REGULAR MEETING AGENDA

Project Name: White Water Car Wash

**Staff Report
White Water Car Wash
2675 Washtenaw Avenue
Preliminary Site Plan and Special Land Use**

Preliminary Site Plan and Special Use Review For Ypsilanti Township, Michigan

DRAWING:
C-3

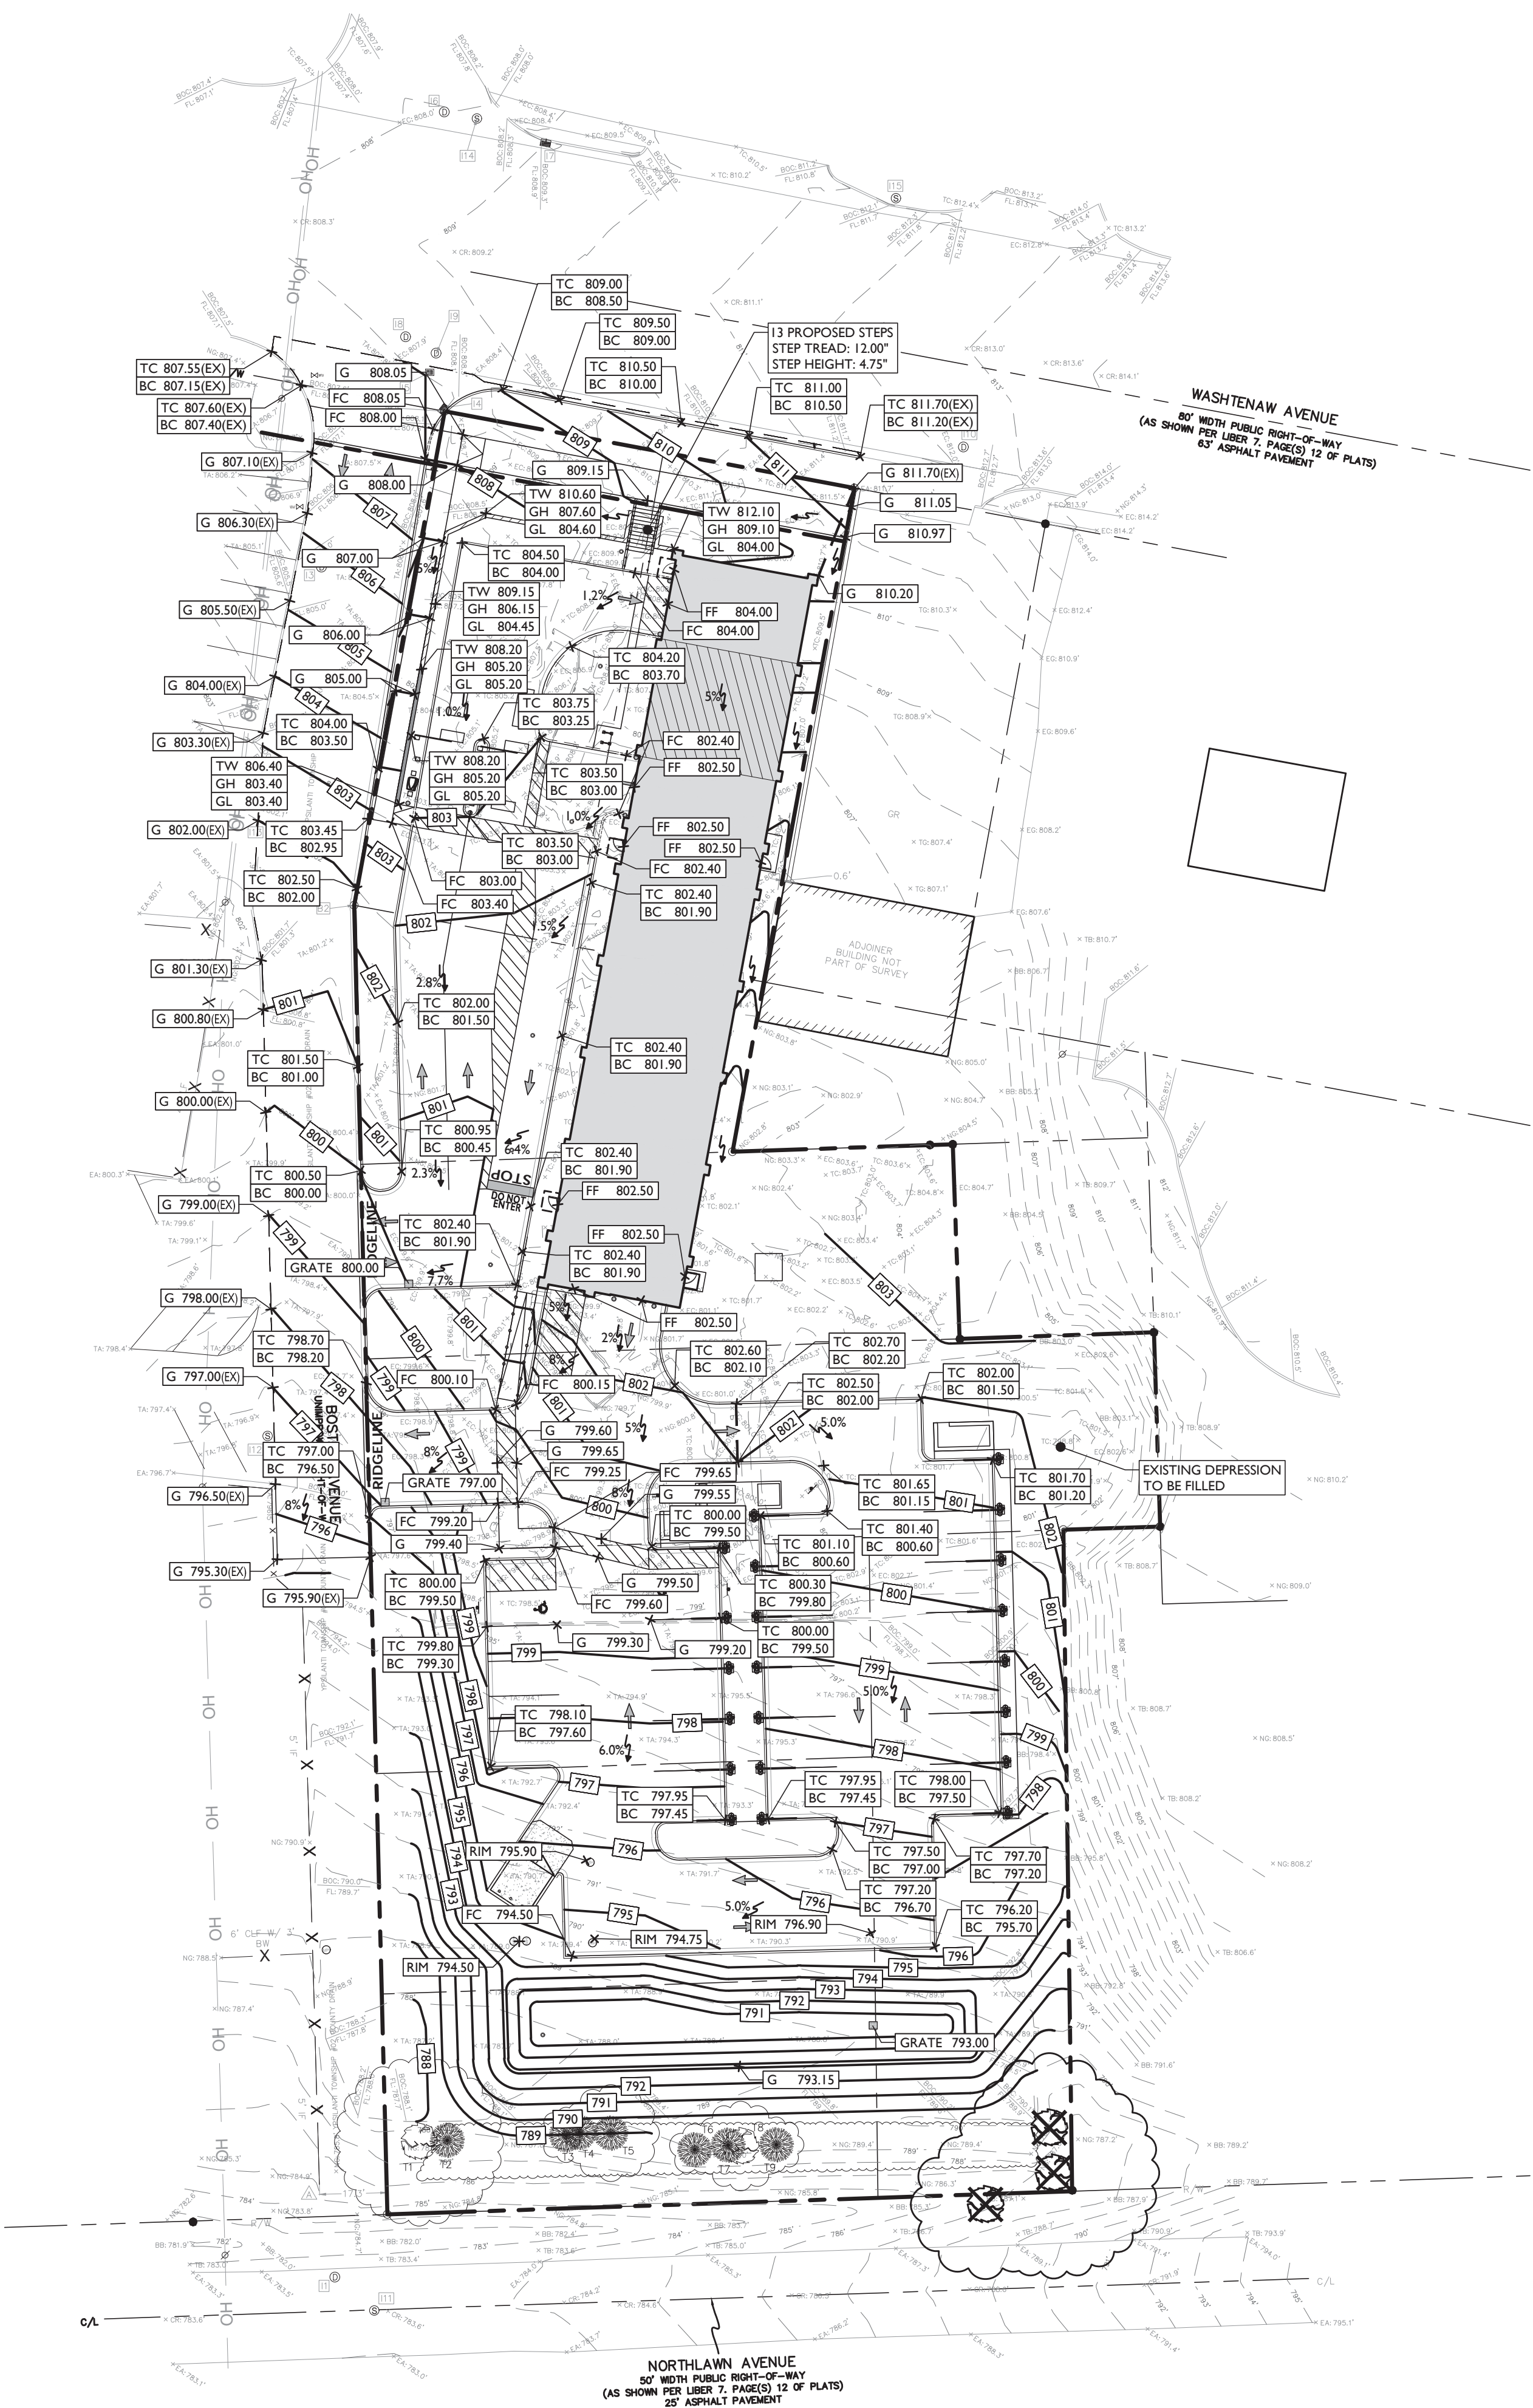
Sheet C-3 indicates that the applicant would like to change the Site Type under the Form Based Code from Site Type A to Site Type C. A Site Type "A" does not permit a vehicle wash use, nor does it allow a Building Form B (as proposed in this application). If the Site Type were changed to "C," then a vehicle wash could be considered as a Special Land Use, and Building Form B would also be allowed.

DRAWING: C-4

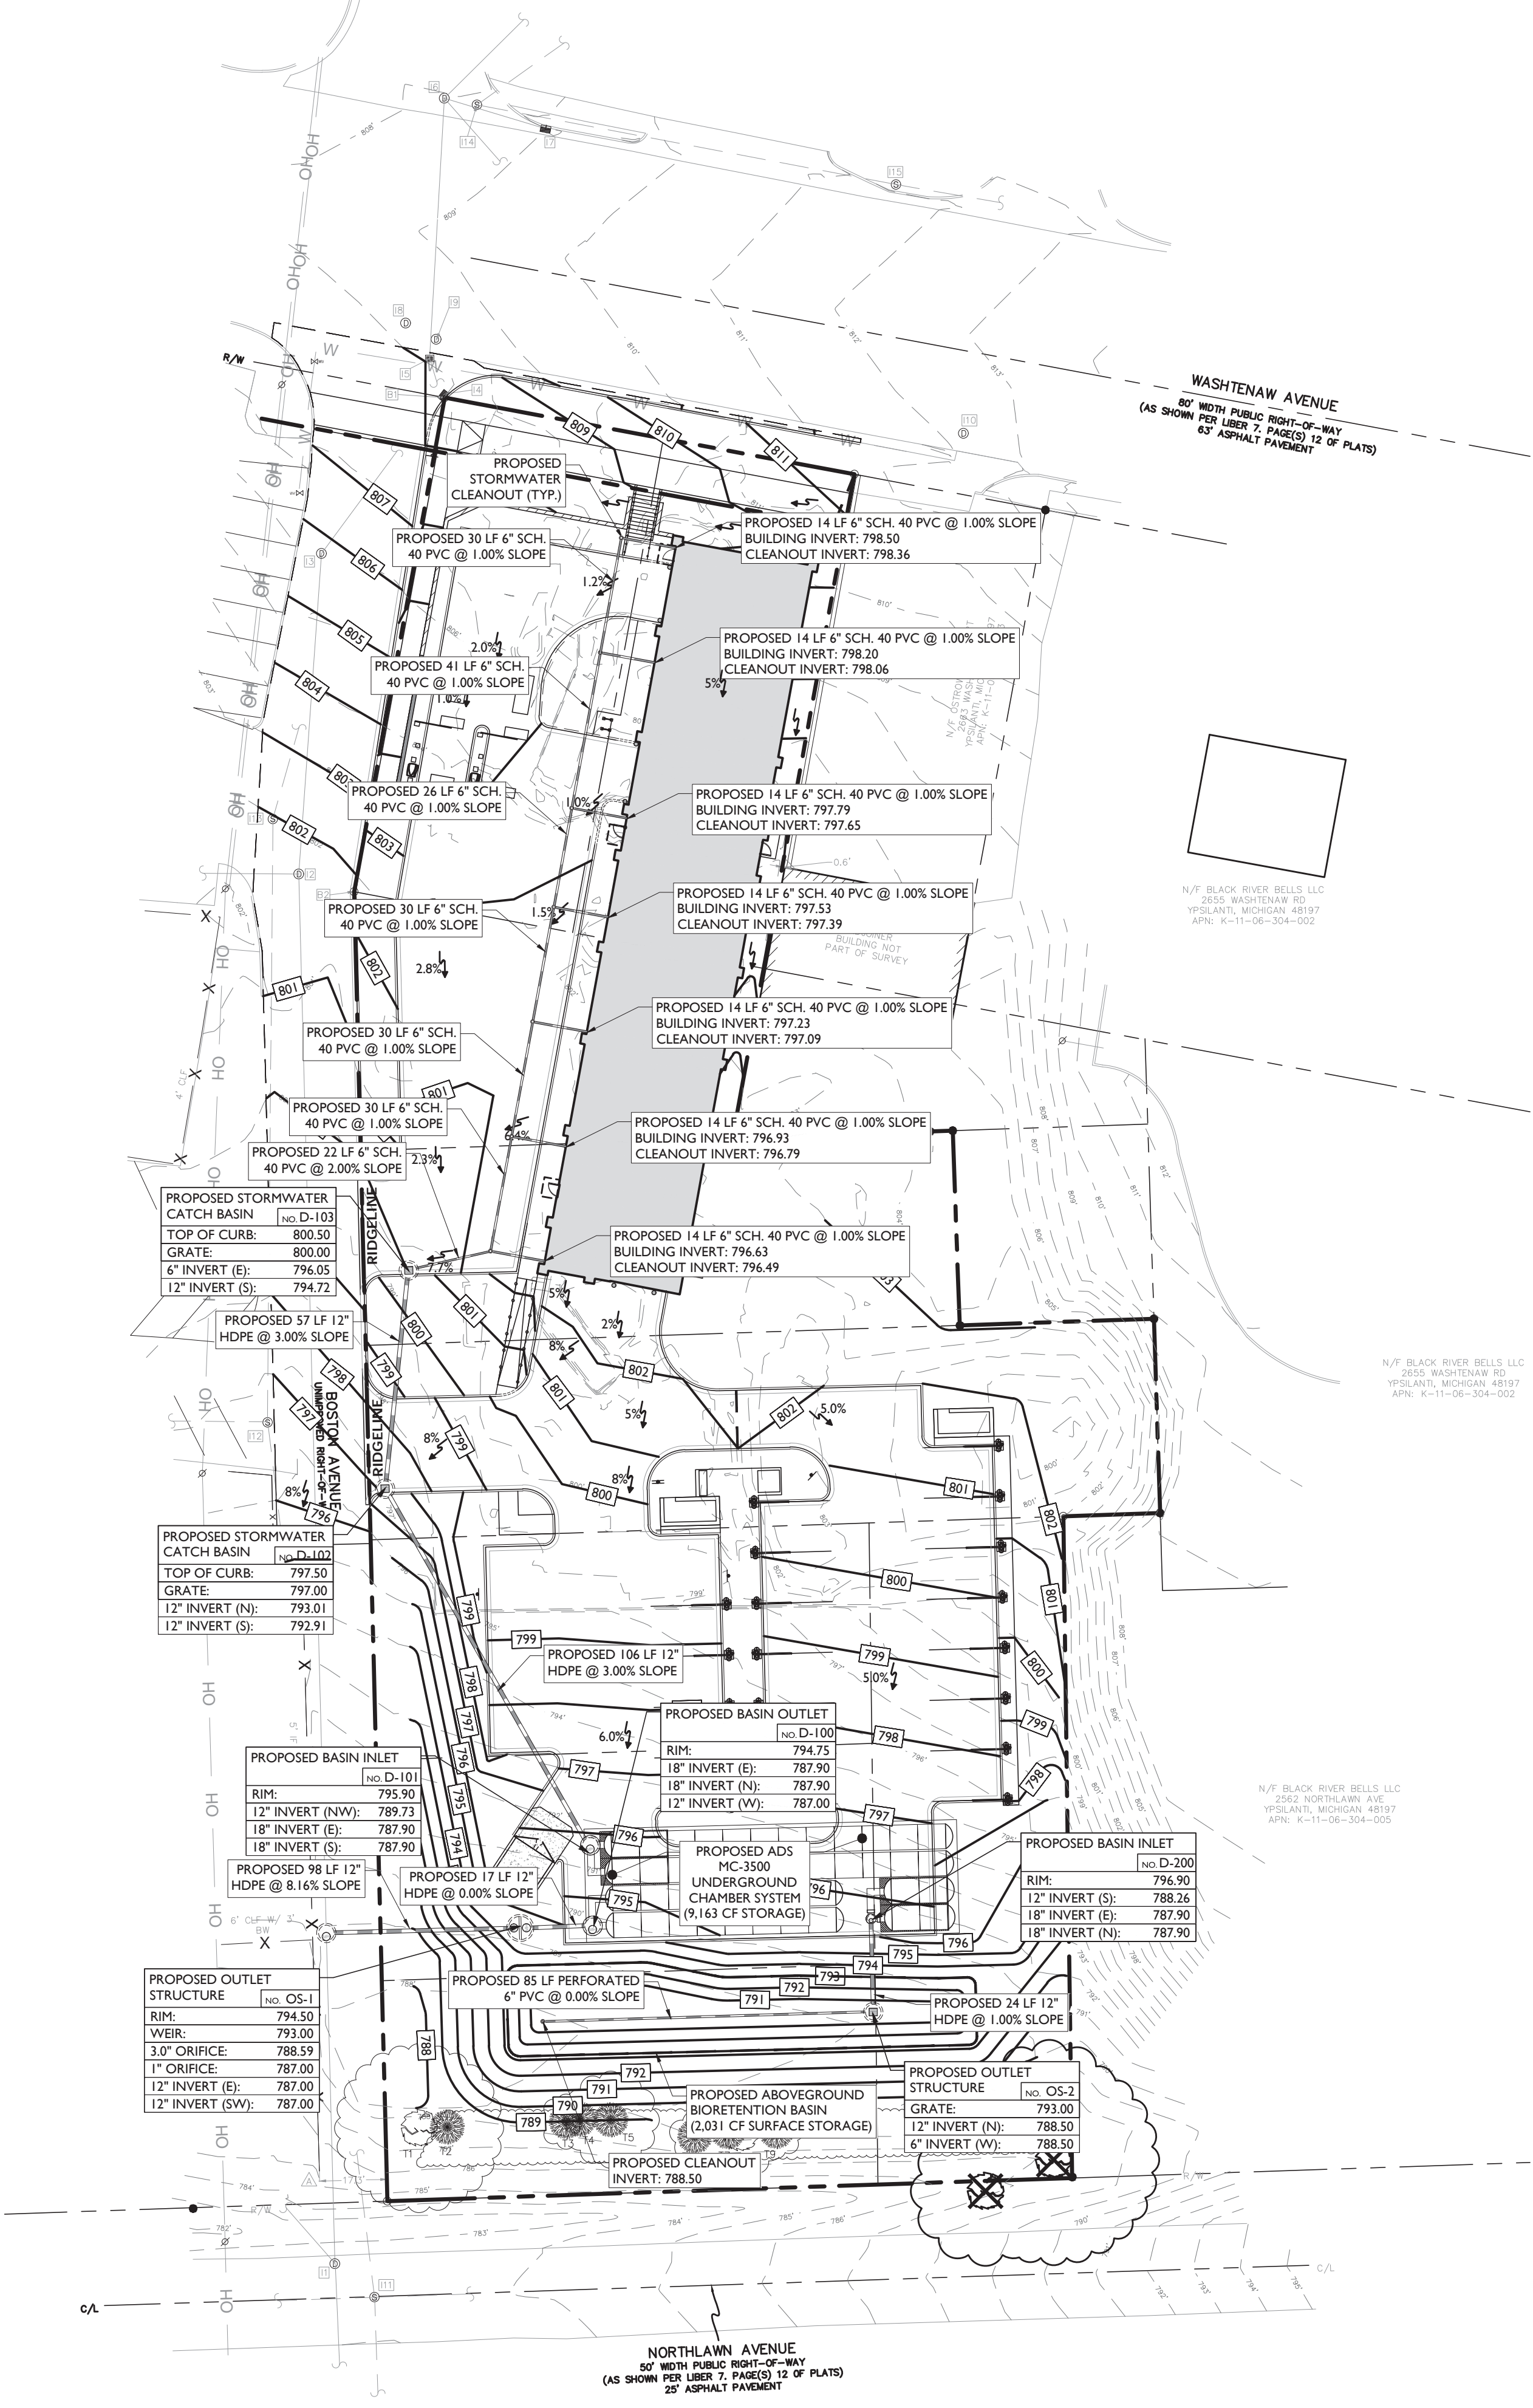
4. The YTD #02 must be identified on every plan sheet where it is depicted.
5. The call outs on the grading plan (plan sheet C-4) cover up structure labels and other information. Please revise for clarity.
